City of Citrus Heights  
Planning Commission and City Council  
6237 Fountain Square Drive  
Citrus Heights, California 95621

Dear Commissioners and Council Members:

20-1

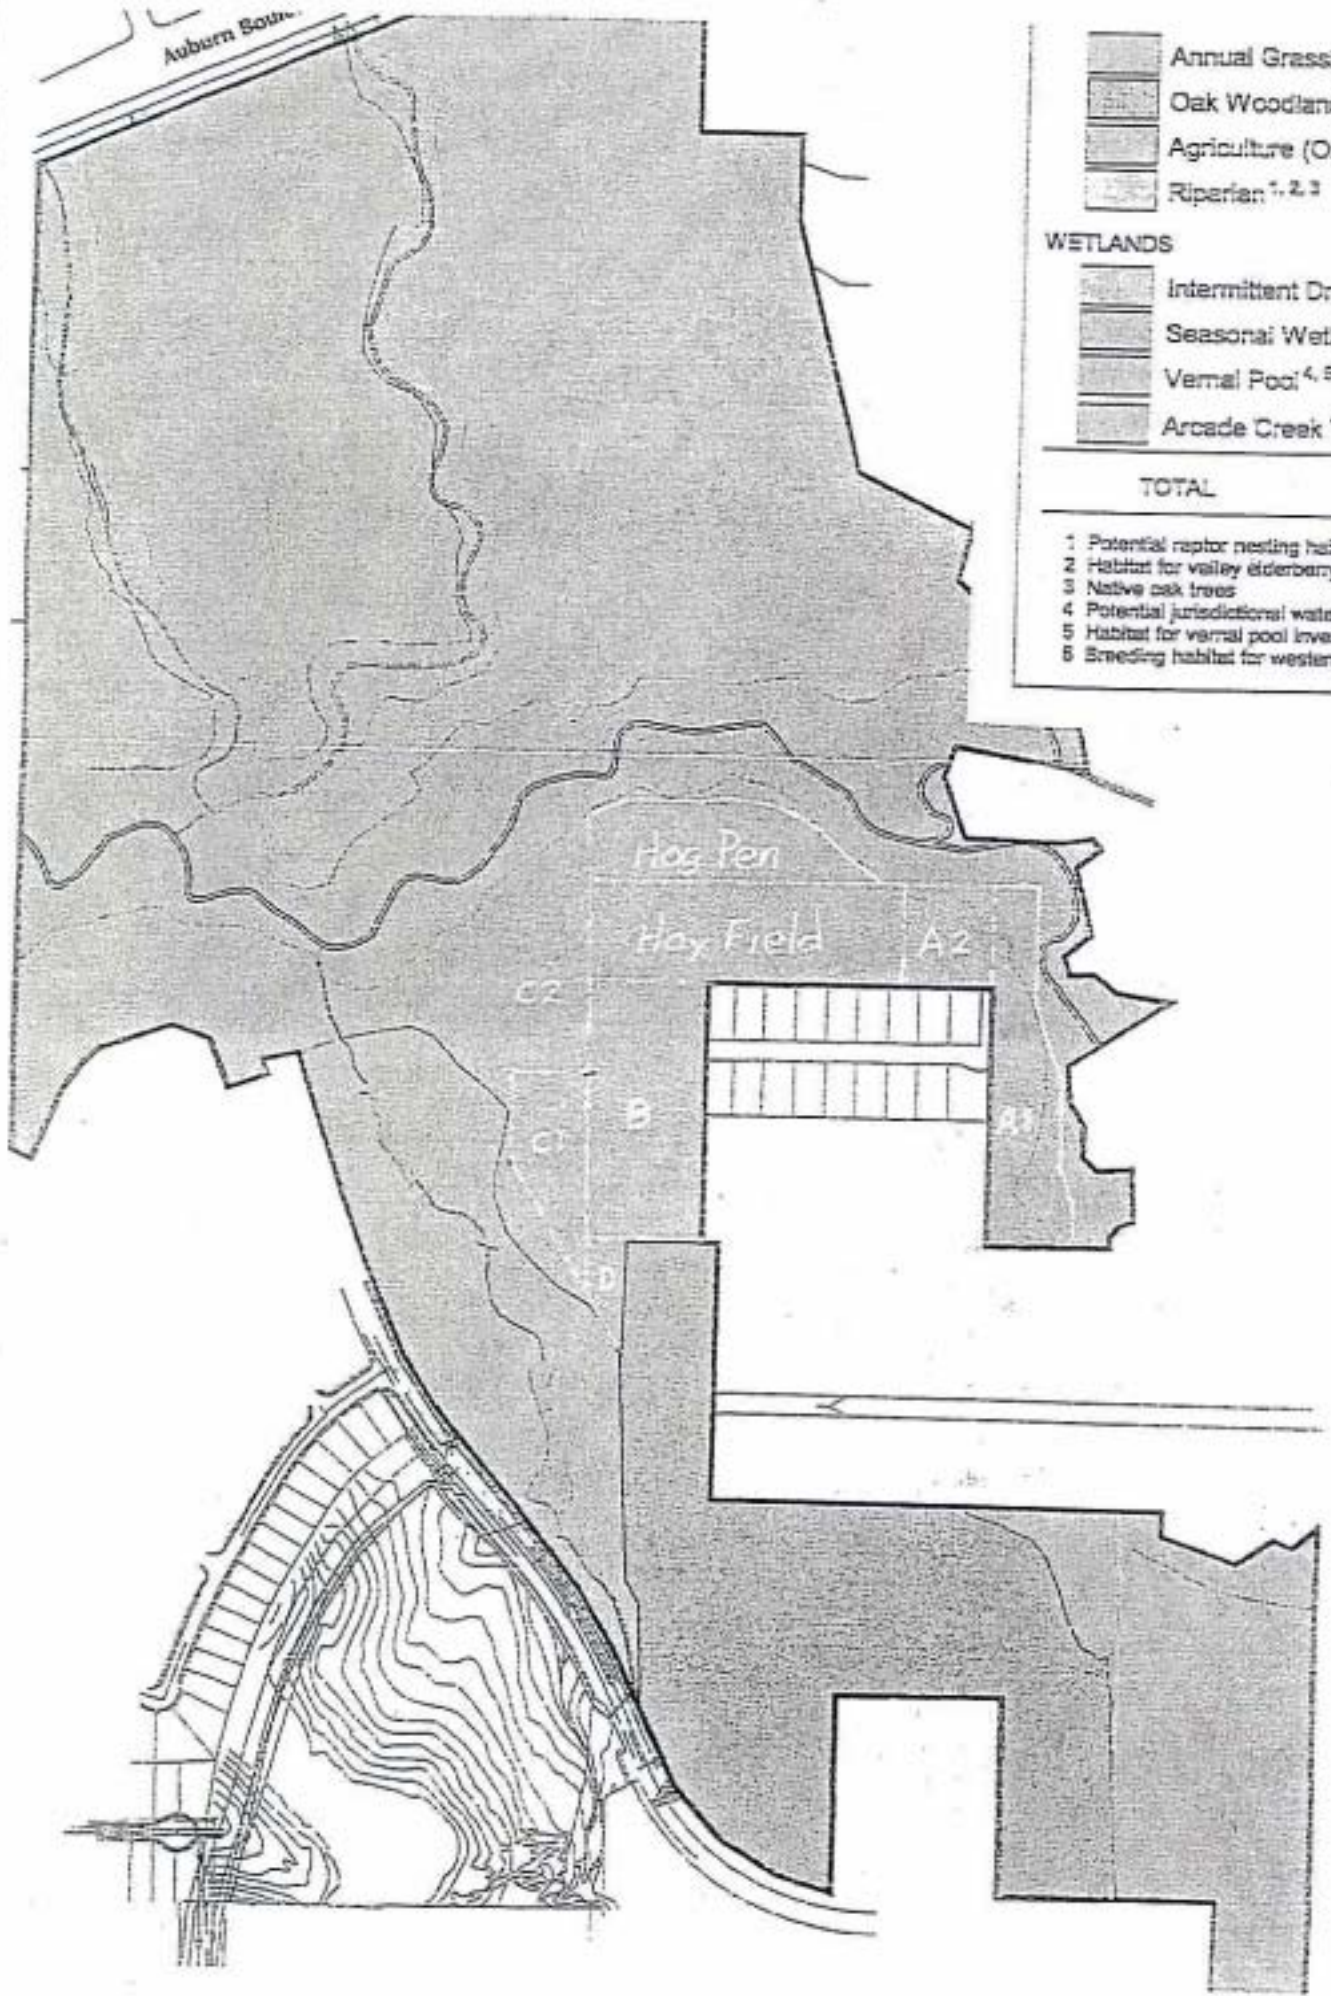
Table 4.9-1 and Figure 4.9-1 both provide information on the amount of acreage present in each habitat type. With the exception of the acreage of Intermittent Drainage, the numbers are essentially the same. There is, however, a 0.84-acre discrepancy in Intermittent Drainage between the two listings. What is more disturbing is the 9.3-acre discrepancy between the total acreage in the Table and the total acreage of the project. According to the map in Figure 4.9-1, every square foot of ground has been placed in one of the habitat categories. Footnote 1 explains, "Acreage does not total to 129 acres due to the measurement techniques used by Foothill Associates." How can more than 7% of the land area be unaccounted for when measurements are reported to 0.01 acre?

2. Seasonal Wetlands, and Riparian Areas, Figure 4.9-1

It should be noted that the wetlands and riparian areas that extend north and south from the Arcade Creek corridor were non-existent just a few years ago. These large fields were dry farmed for many years and the entire area was tilled annually. It wasn't until development of the land across Auburn Boulevard and Greenback Lane that year-round runoff allowed vegetation to thrive.

Figure 4.9-1 designates 18.63 acres of oak woodland in addition to the riparian areas along the creeks, which are also covered with oak trees.

I believe that much of this oak woodland is misidentified. I would like to call particular attention to the area that lies on the north, east, and west sides of the Woodside Drive SPA.

To help you understand my opinions, I would like to display a map and several photographs. The map is a reproduction of Figure 4.9-1 to which I have added fence lines and my own "Lot designations" for individual portions. The photographs show specific sites within these lots.

Lot A is approximately 2.85 acres and is a part of the almond orchard that is shown on the south side of the project. When originally planted approximately 100 years ago, the almond orchard also included all of the Woodside Drive SPA that lies west of San Juan Creek.

Photo #1

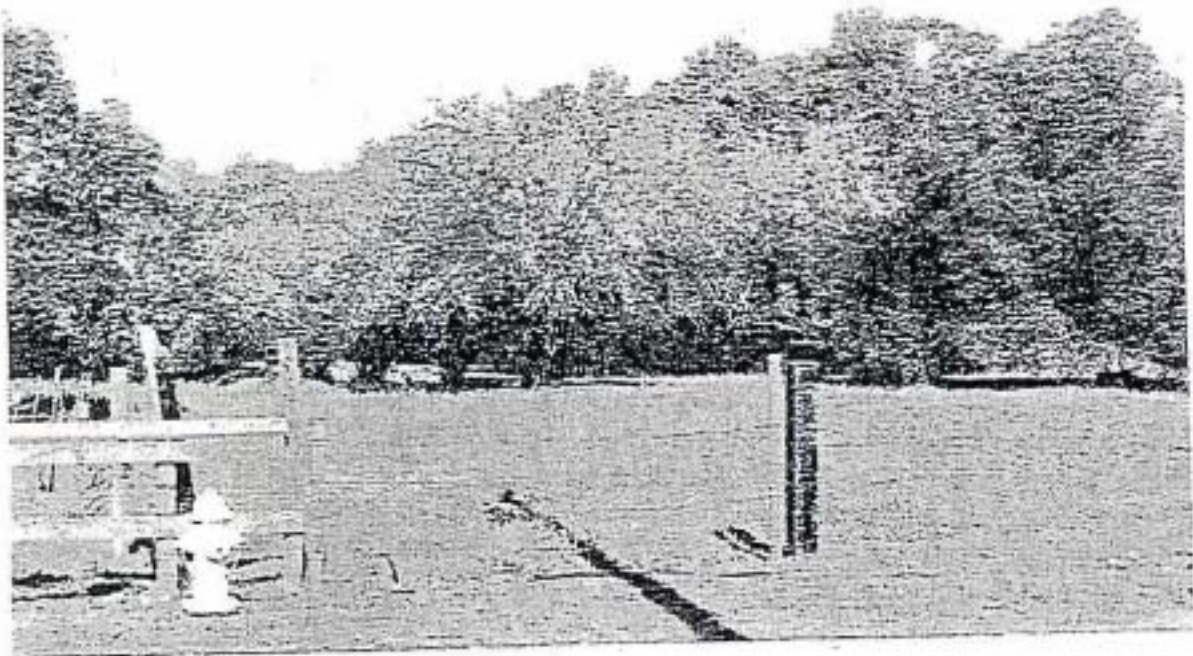
Lot A1 varies in width from approximately 115 feet at the North end to 150 feet where it fronts on Woodside Drive. It is approximately 730 feet deep and contains approximately 2 acres. Photo #1 is a view of Lot A1 taken from Woodside Drive. Photo #2 was taken from the interior of the lot. Several oak trees are growing on the boundaries of the lot, but only a couple of decent trees are growing within the boundaries of the lot.

Photo #3

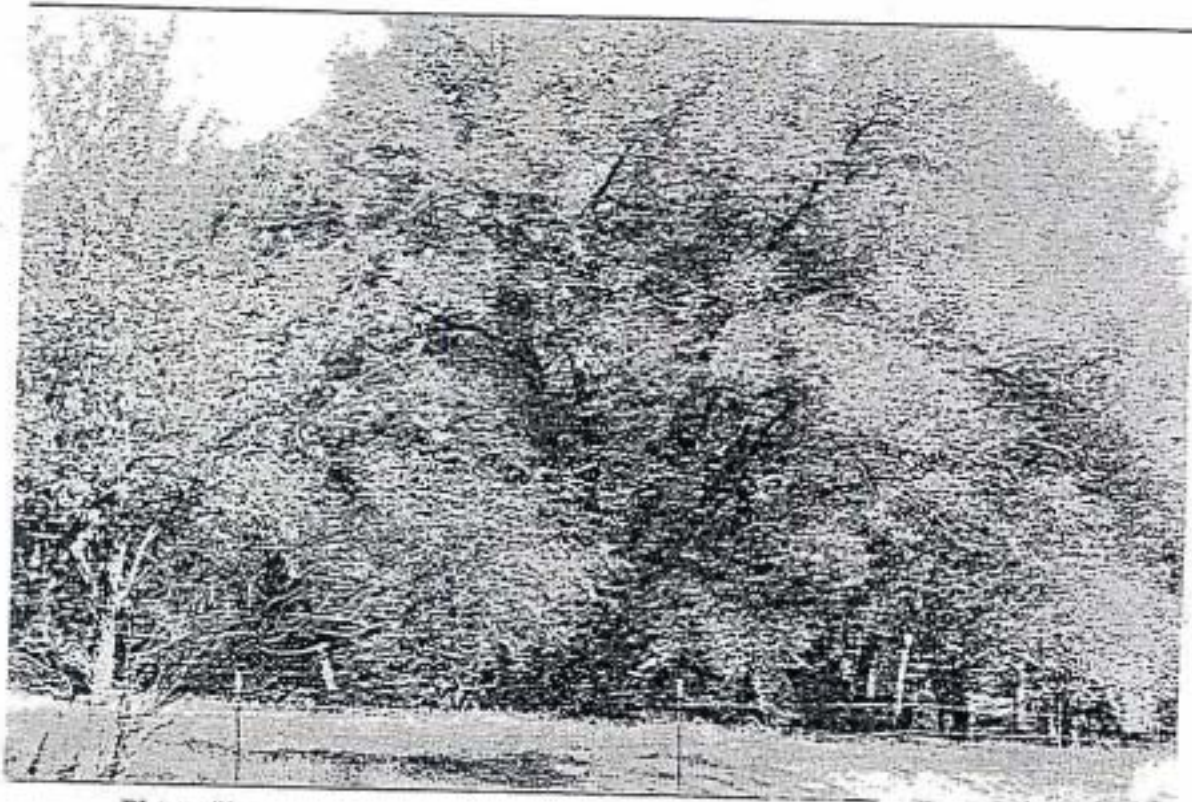
The only respectable tree on the lot is shown in Photo #3 and is on the eastern edge and approximately 50 feet north of the Woodside Drive centerline. The remainder of the trees grow along side pre-existing almond trees and as a result are deformed as shown in Photos #4 and #5. The tree in Photo #5 might have been a decent tree but it has an obvious problem.

Photo #7

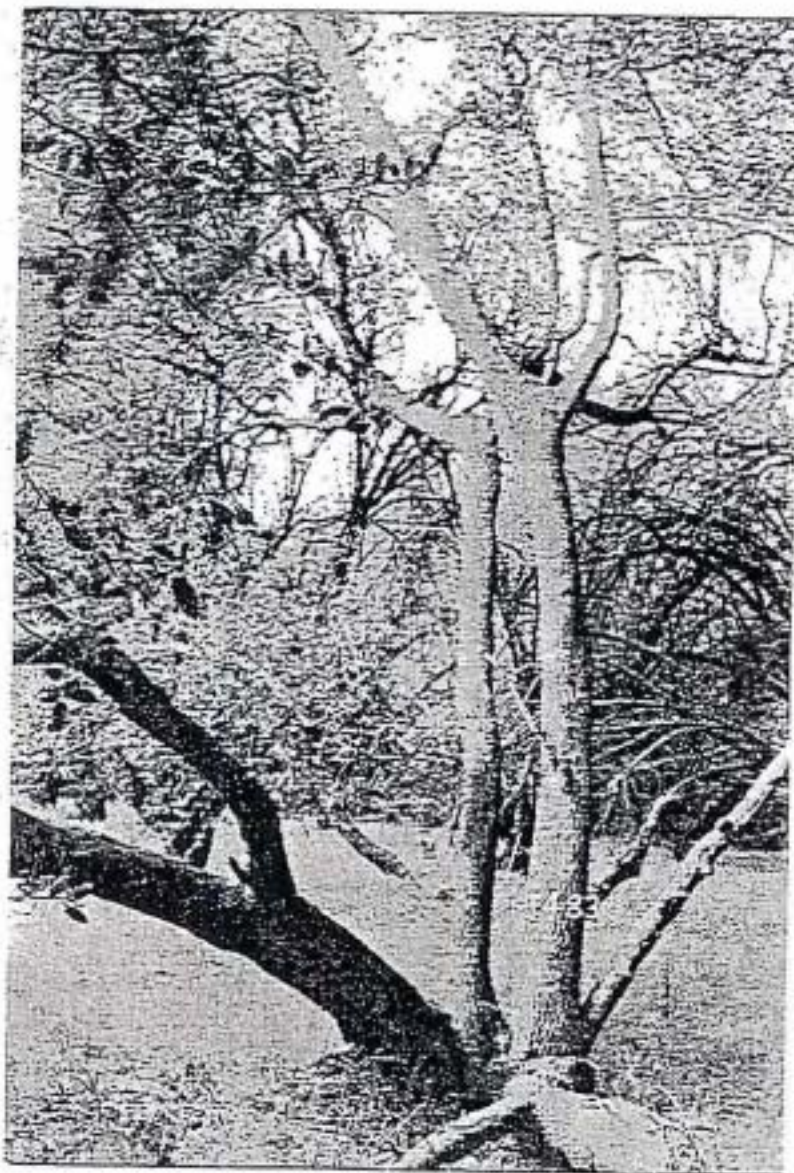
Photo # 7 shows tree #1483 of the survey. This tree has four trunks coming out of the ground. The two on the south side fell last year and the other two will probably go soon.

Photo #9

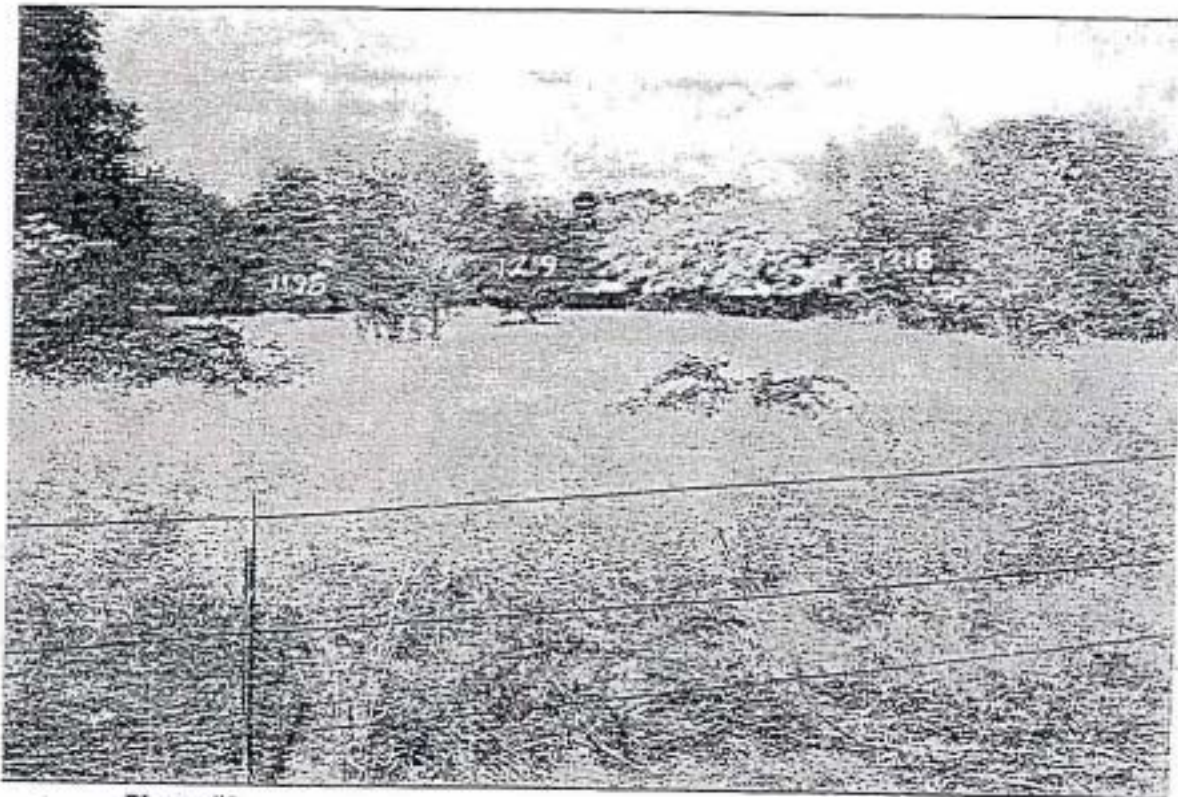
Lot B was once an alfalfa field on the Van Maren Ranch. It is approximately 235 feet wide and 520 feet deep, making approximately 2.8 acres. Photo #9 was taken from the approximate centerline of the extension of Woodside Drive. The oak trees at the left edge of the photo are in the fence line between Lots B and C. The row of mulberry trees is on the eastern boundary of the lot. Tree #1218, which is identified in the picture, is the closest tree to Woodside Drive and it is approximately 275 feet from the road. Tree #1219 is approximately 335 feet from the road and tree #1198 is approximately 370 feet. One other scrubby bush that the tree survey called tree #1173 is in the almond orchard remnant and is just out of sight off the right edge of the photo and is shown in Photo #10.

Photo #11

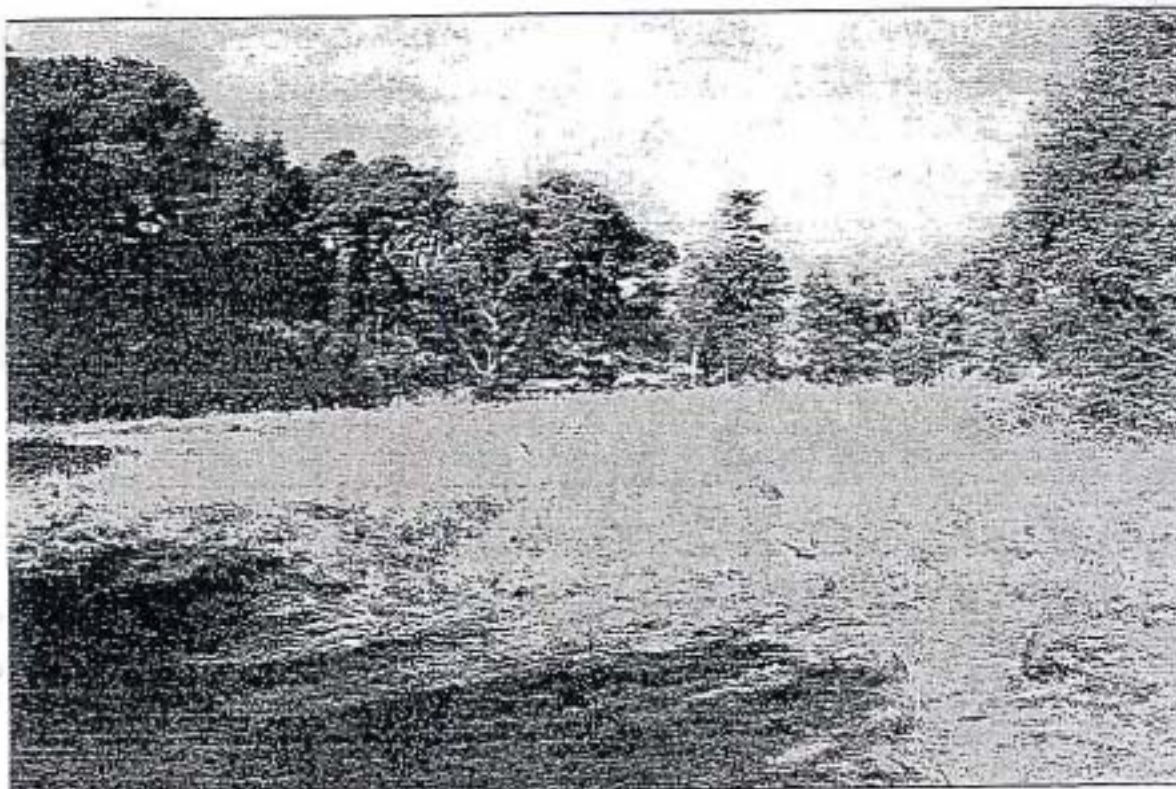
Lot C1, shown in Photo #11, is approximately 170 feet wide and contains approximately 1.25 acres. This area was formerly used as a turkey pen. All of the trees are growing in the fence lines. Trees #1100, 1101, 1103, and 1104 in Photos #12 and #13 are typical of the trees on the western boundary.

Unfortunately trees are much like people. They grow, they mature, they get old, their bodies become weak and brittle, and they fall down and die. To allow any kind of public activity near any of these trees would border on gross negligence. Yet these trees are within the boundaries of the proposed park.
